**Re: Partially Recirculated Draft Environmental Impact Report /  
Supplemental Draft Environmental Impact Statement  
(RDEIR/SDEIS) for the Bay Delta Conservation Plan/WaterFix**

Comments on the July 2015

Bay Delta Conservation Plan / California WaterFix

Partially Recirculated Draft Environmental Impact Report /  
Supplemental Draft Environmental Impact Statement

**Figure 3-2. Old and Middle River flow when HORB is closed**

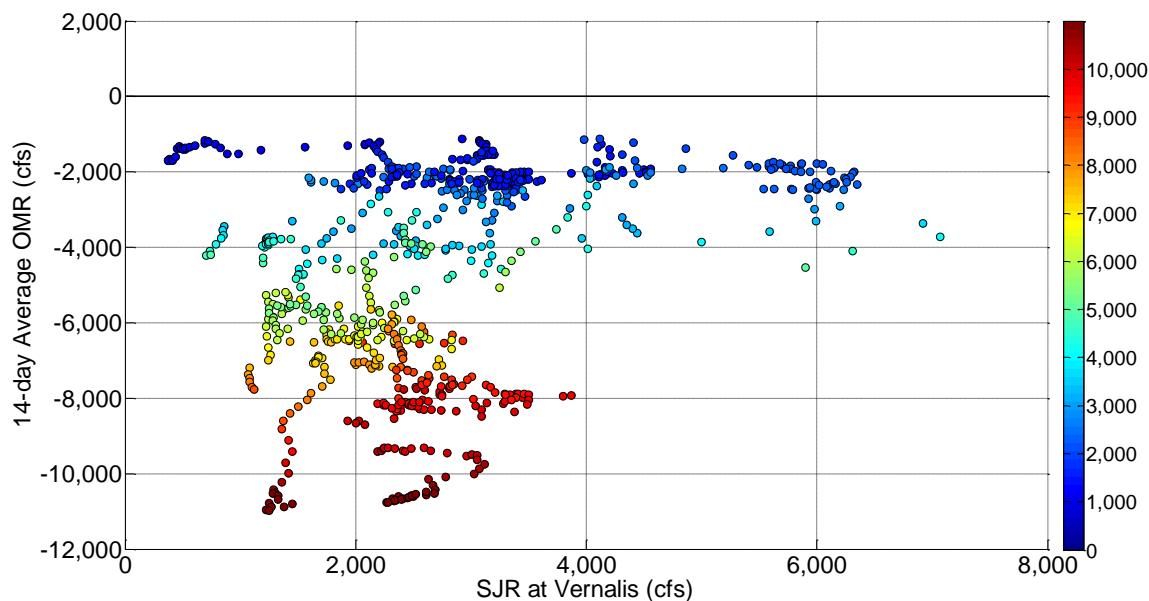
Closure of the HORB blocks flow in the San Joaquin River from entering Old River which, as discussed above, is the only source of positive OMR; closure of the HORB thus prevents OMR from being positive. As a result, the project description for OMR flow requirements is internally inconsistent with the project description for HORB operation in two-thirds of the analysis period.

This inconsistency is demonstrated by reviewing measurements of OMR flows at times when a barrier has been installed at the head of Old River in the past. Historically, a temporary barrier of rocks at the head of Old River has been constructed in the fall or spring<sup>1</sup>. Review of OMR flows that were measured when the HORB was installed confirms that OMR is never positive with the HORB installed (Figure 3-2).

Pumping at the existing CVP and SWP export facilities in the south Delta (Jones and Banks, respectively) contributes to negative OMR – the greater the total pumping at the existing south Delta facilities, the more negative OMR (Figure 3-2). Limiting pumping at the south Delta facilities limits the negative OMR but cannot create positive OMR. Positive OMR can only occur with inflow from the San Joaquin River when the HORB is *not* installed.

**Figure 3-3. Frequency of Excess Outflow in October**

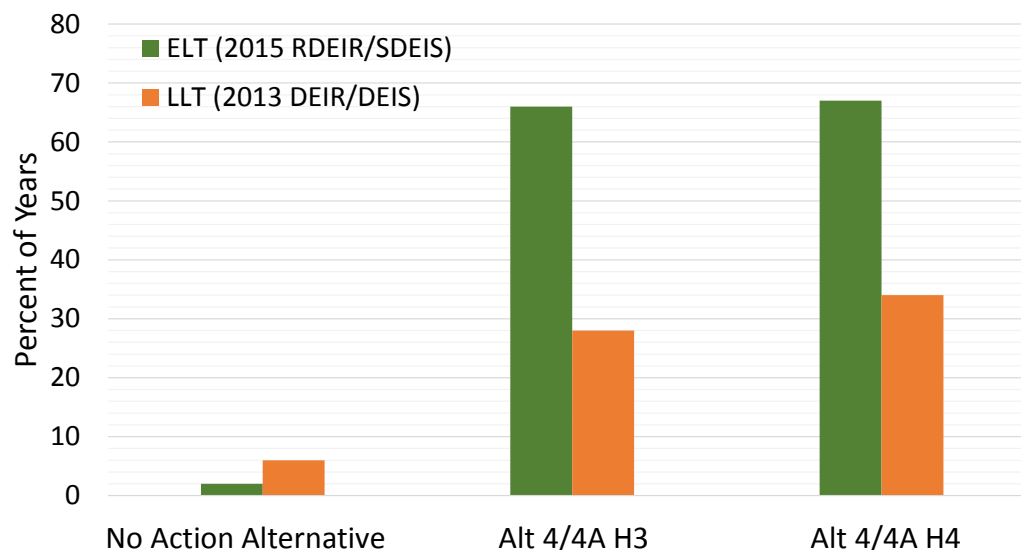
However, the BDCP modeling indicates that Delta outflow would exceed the amount necessary to meet minimum outflow requirements and salinity standards over 66% of the time in the early long term (ELT) for Alternatives 4/4A<sup>2</sup> H3 and H4 (Figure 3-3). In comparison, the No Action Alternative<sup>3</sup> has excess Delta outflow in October only 2% of the time in the ELT.

The dramatic increase in the occurrence of excess flow under Alternatives 4/4A H3 and H4 in the ELT is not as substantial in the late long term (LLT) and is probably the cause for the different impact determinations between the ELT (as analyzed in the RDEIR/SDEIS) and the LLT (as analyzed in the 2013 BDCP Draft EIR/EIS). Although excess October Delta outflow occurs less often in the Alternative 4/4A LLT modeling than in the Alternative 4/4A ELT modeling, the frequency of occurrence in the LLT modeling is also unrealistic.

**Figure 3-4. Closure of the Delta Cross Channel maintains higher flow in the Sacramento River**

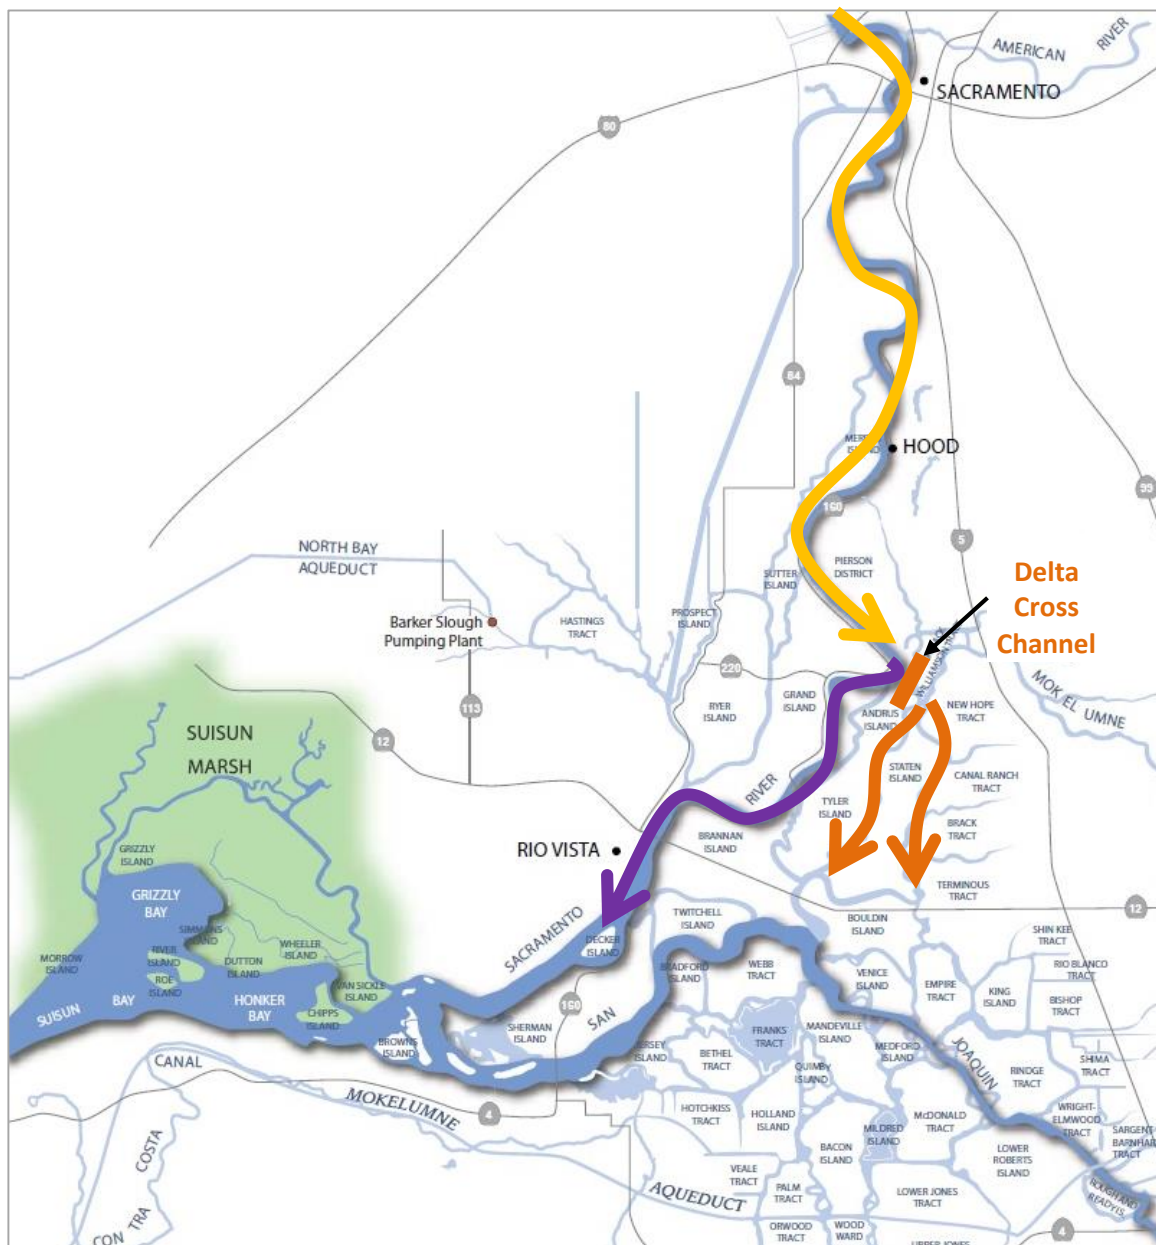
The operational strategy to close the Delta Cross Channel to meet Rio Vista flows without unnecessary reservoir releases has been implemented recently in November of 2009 and in October of 2013 and 2014 (Reclamation, 2015). This is the realistic operational strategy that should have been used in the modeling. Failure to model this operational strategy, when it has in fact been implemented repeatedly in recent years, biases the salinity results in the water quality impacts analysis, showing reduced salinity with the project. In reality, when the Rio Vista flow requirements are met by closing the Delta Cross Channel instead of by releasing flow from upstream reservoirs, interior Delta salinity will increase with the project.

**Figure 3-5. Excess Delta Outflow in the month of October during the Early Long Term biases the modeling results for multiple months**

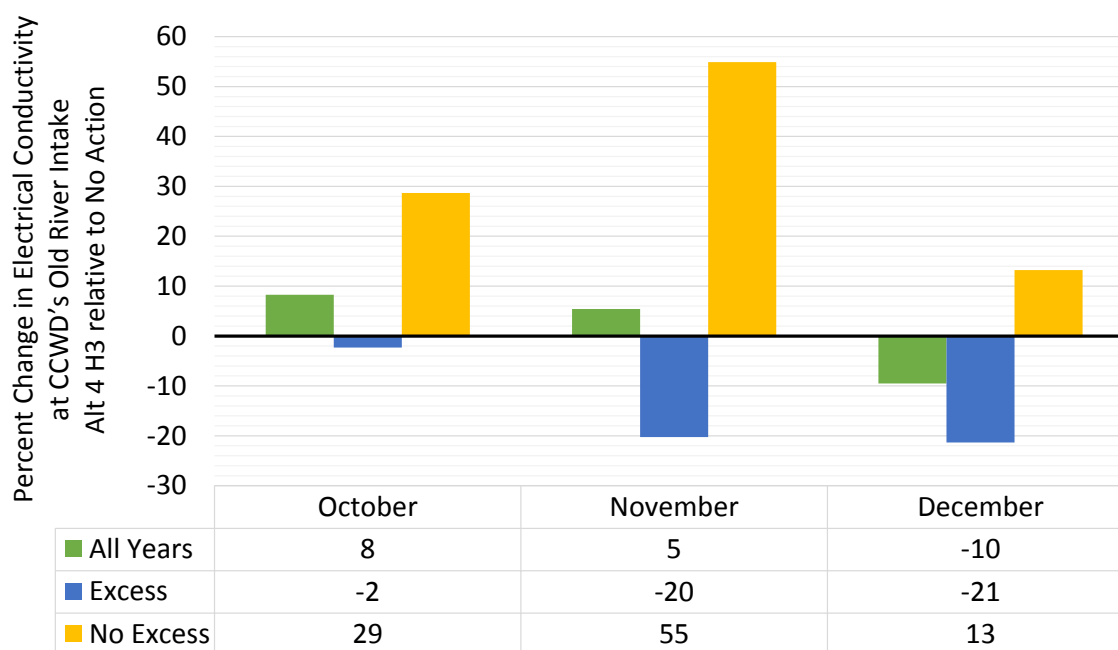
The unrealistic excess Delta outflow in October freshens the modeled interior Delta salinity for many months. This is illustrated in Figure 3-5, which shows that excess Delta outflow in October freshens the water at CCWD's Old River Intake in October and that the freshening effect is maintained through December (blue bars in Figure 3-5). In contrast, during years without excess Delta outflow in October, Alternative 4/4A H3 increases the salinity at CCWD's Old River Intake in October, November, and December (orange bars in Figure 3-5). Further, averaging salinity over all years (green bars in Figure 3-5) underestimates the impacts that would occur.

This discussion serves to show that the unrealistic assumption of excess Delta outflow results in a significant underestimation of salinity impacts as a result of the proposed project. Conversely, implementing and modeling an operations plan that corrects this unrealistic excess Delta outflow assumption would reveal greater salinity impacts due to the project.

**Figure 5-1. Change in Salinity due to the ELT Tidal Marsh**

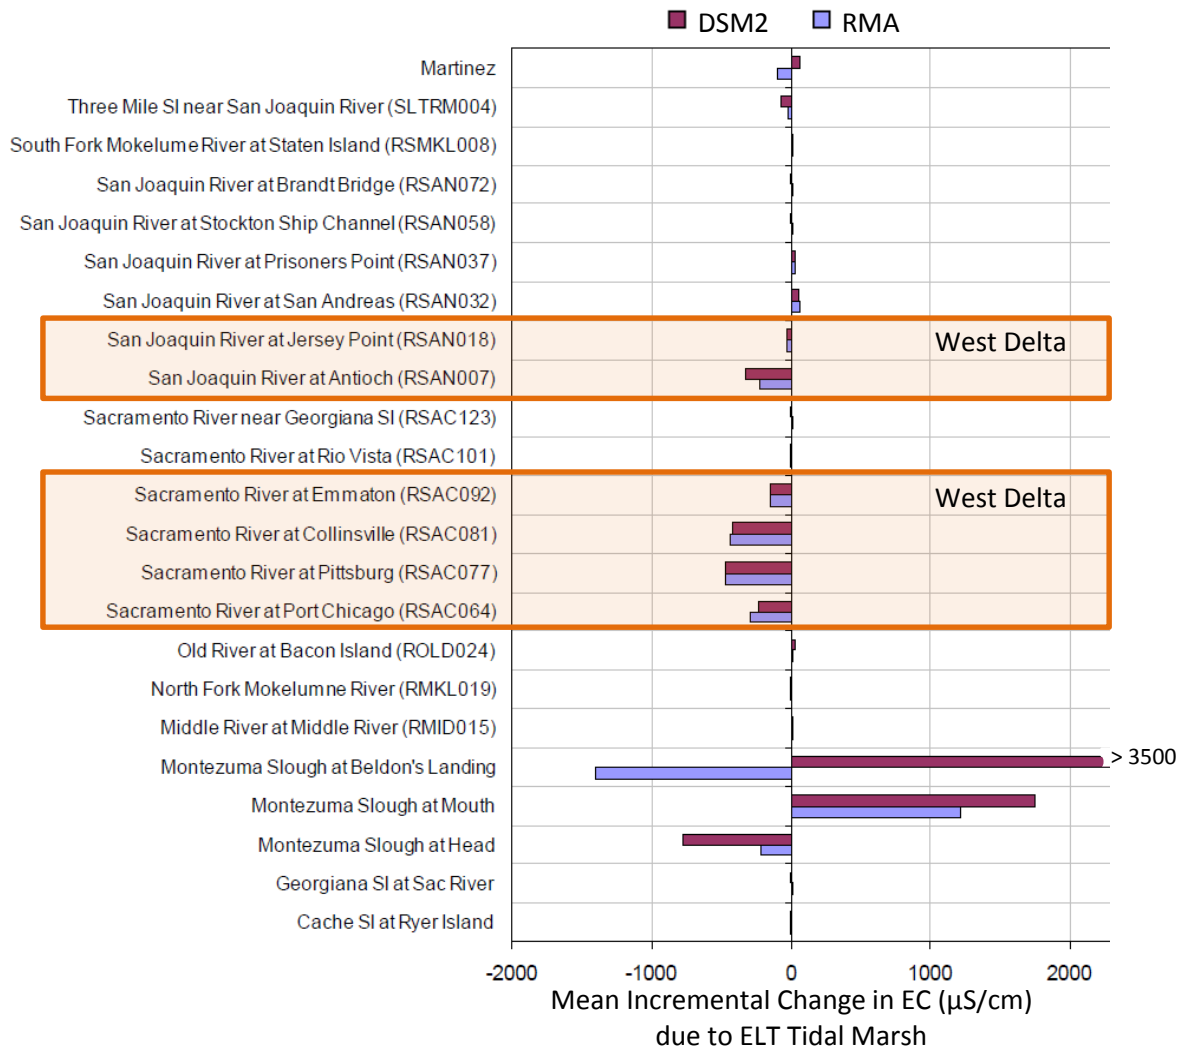
However, there is no evidence presented in the RDEIR/SDEIS to support this conclusion. To the contrary, the analysis in the 2013 BDCP Draft EIR/EIS clearly indicates that the particular configuration of tidal marsh included in the modeling *underestimates* salinity impacts, since the modeled restoration reduces salinity in the western Delta. For example, Figure 5-1 below is a reproduction of a figure from the 2013 BDCP Draft EIR/EIS that shows the incremental change in electrical conductivity (EC) due to the ELT tidal marsh configuration (25,000 acres) that was assumed in the models; the locations in the west Delta are boxed for easy identification. At every location analyzed in the west Delta, the mean incremental change in EC due to the ELT tidal marsh is negative, indicating that the incorporation of the ELT tidal marsh reduces salinity at these locations for both models that are used to simulate salinity in the Delta (i.e., DSM2 and RMA). Multiple figures in the 2013 BDCP Draft EIR/EIS illustrate that the ELT tidal marsh configuration reduces salinity in the west Delta. *See, e.g.*, 2013 BDCP Draft EIR/EIS, Appendix 5A, Section D, Attachment 2, Figures 6-26, 6-29, 6-32, 6-35, and 6-41 and Attachment 4, Figures 1-69 to 1-72.

In short, the tidal marsh assumed for the ELT reduces salinity in the west Delta. Thus, including the ELT tidal marsh in the modeling to simulate the project alternatives, when in fact the tidal marsh will not be constructed as part of the alternatives, *underestimates* the impacts to salinity in the west Delta that would be caused by the alternatives.

**Figure 5-2. Monthly Average Salinity at Collinsville both with and without operation of the SMSCG**

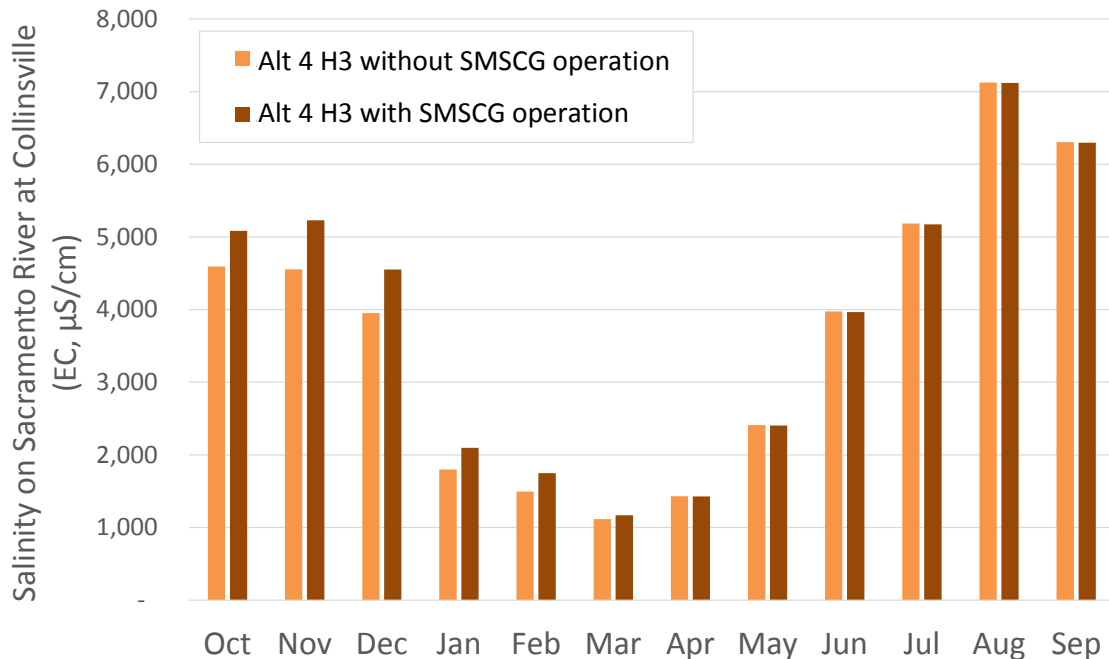
Operation of the gates creates a net flow of fresh water from the Sacramento River near Collinsville into Suisun Marsh equivalent to about 2,800 cubic feet per second (cfs), thus reducing salinity within Suisun Marsh (Enright, 2008, slide 40). The RDEIR/SDEIS contains graphs showing the reduction in salinity within Suisun Marsh in response to operation of the gates. RDEIR/SDEIS, Appendix A, Appendix 8H, Attachment 1 at p. 10 (Figures 9 and 4).

However, diversions of the freshwater into Suisun Marsh via operation of SMSCG *increase* salinity in Suisun Bay and the western Delta (Enright, 2008, slides 43 and 44). The RDEIR/SDEIS does not disclose the degradation in water quality that SMSCG operation would have within Suisun Bay or the Delta. Figure 5-2 below shows changes in salinity in the western Delta at Collinsville that are caused by SMSCG operations. The increase in salinity from October through March is an effect of project operations that is not captured by the outdated modeling that was used to evaluate water quality impacts.

**Figure 5-3. HORB affects water quality in the south and central Delta**

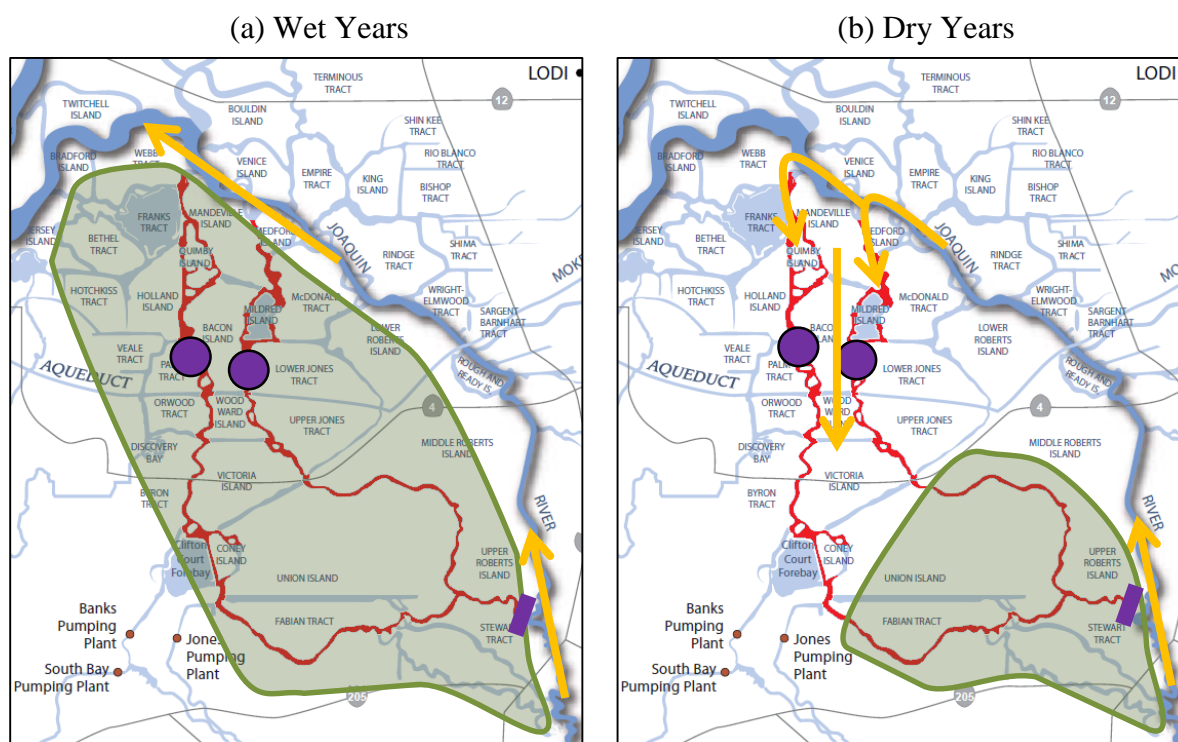
Closure of the HORB impacts the water quality in the south and central Delta; Figure 5-3 shows the geographical extent of the impacts in wet and dry years.

During dry years, the project as described in the RDEIR/SDEIS allows OMR to be negative while the HORB is closed. With no flow entering Old River from the San Joaquin River at the HORB, and with the export pumps operating, the San Joaquin River would flow north past the HORB, then turn south entering Old and Middle Rivers from the north and creating negative OMR (Figure 5-3(b)). The central Delta would receive this water heading from the north, and thus would receive a greater proportion of San Joaquin River water as compared to baseline conditions. This is an important consideration for water quality in the central Delta, since during dry years, San Joaquin River flows are generally low and the water quality is poor. Further, with the HORB closed, stagnant conditions would be created in the south Delta.

For both wet and dry years, impacts would be greater than what is modeled. In the stagnant regions, flow in the channels would oscillate with the tides, but without net flow, the residence time would be very long. (Residence time is estimated by the volume of water in a region divided by the net flow through the region, so as the net flow approaches zero, the residence time approaches infinity.) Long residence times provide optimal conditions for harmful algal blooms as discussed in Section 2.2.1.2 of CCWD's July 25, 2014 comment letter on the 2013 BDCP Draft EIR/EIS.

**Figure 5-4. HORB affects water quality in the south and central Delta, sensitivity study results**

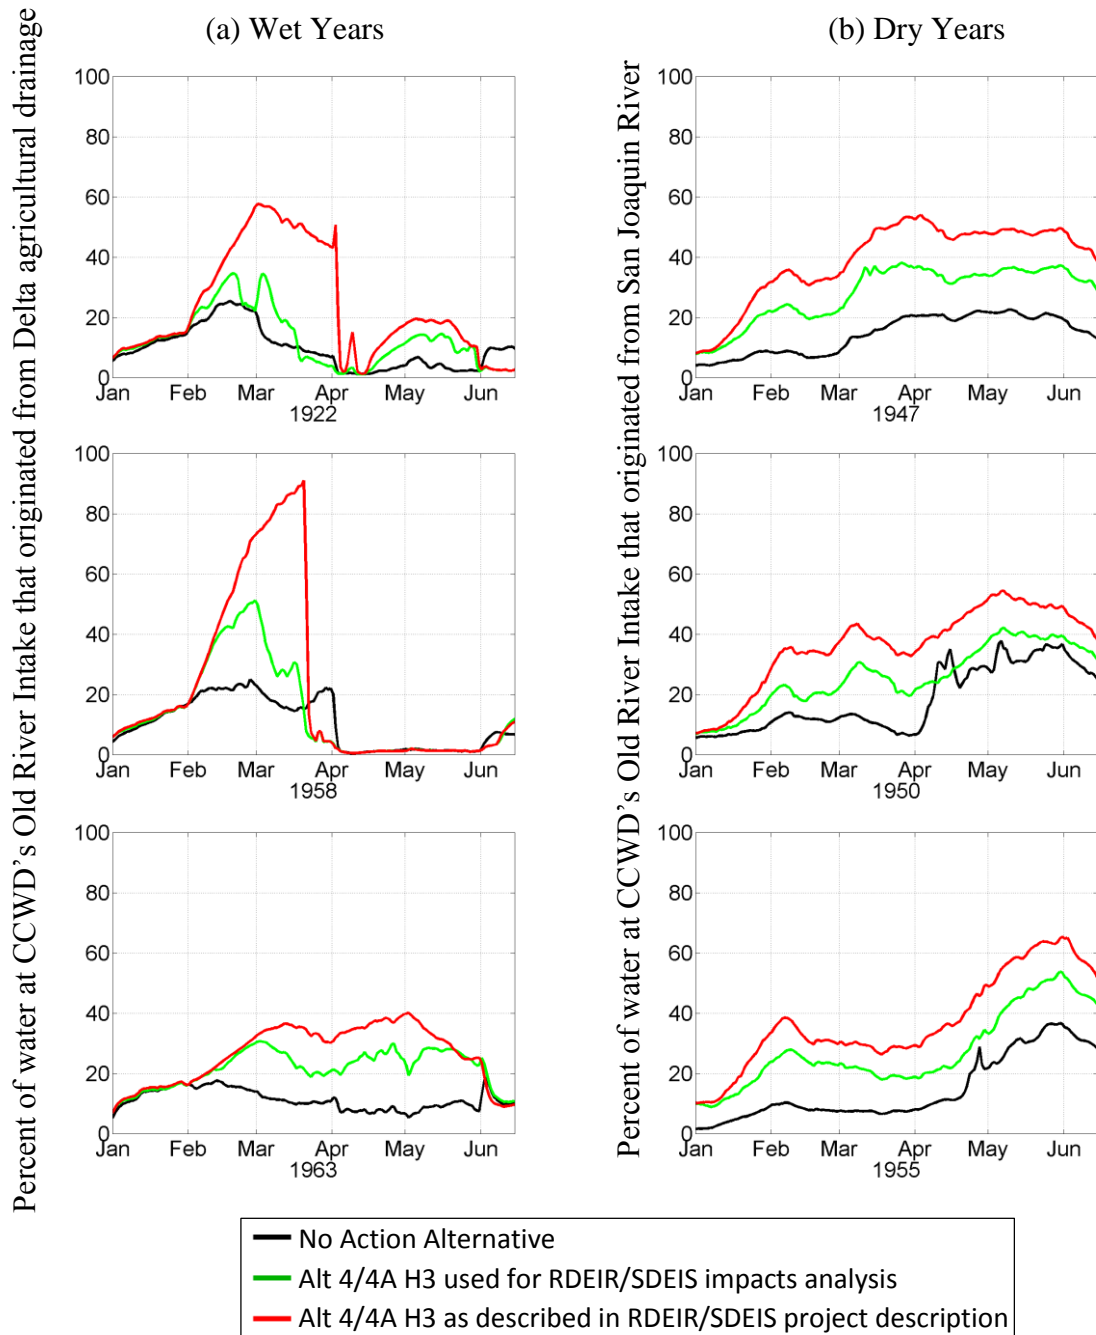
CCWD conducted a sensitivity study to evaluate the degree to which the analysis in the RDEIR/SDEIS underestimates the impacts of the new alternatives. Unlike the modeling used for the impact analysis in the RDEIR/SDEIS, CCWD's sensitivity study assumes that the HORB is closed when the project description indicates it should be closed. The CCWD study also reduced south Delta exports if necessary to attempt to meet the OMR requirement. Note that because no parameters are indicated in the project description to open the HORB for water quality or water stage concerns, this was not simulated in the CCWD study. Figure 5-4 illustrates the results for three wet years (Figure 5-4(a)) and three dry years (Figure 5-4(b)). In all six years, the negative water quality effects of the proposed project are greater than what is disclosed and evaluated in the RDEIR/SDEIS.

Results of CCWD's sensitivity study (red lines) indicate that the modeling used for the RDEIR/SDEIS impacts analysis (green lines) underestimate the project's adverse impacts on water quality relative to the baseline (black lines). In relatively wet years (a), an increase in percent of water from Delta agricultural drainage would increase salinity, nutrients, algal biomass, and pesticides at CCWD's intakes. In relatively dry years (b), an increase in the percent of water from the San Joaquin River would increase salinity, nutrients, and pesticides at CCWD's intakes.
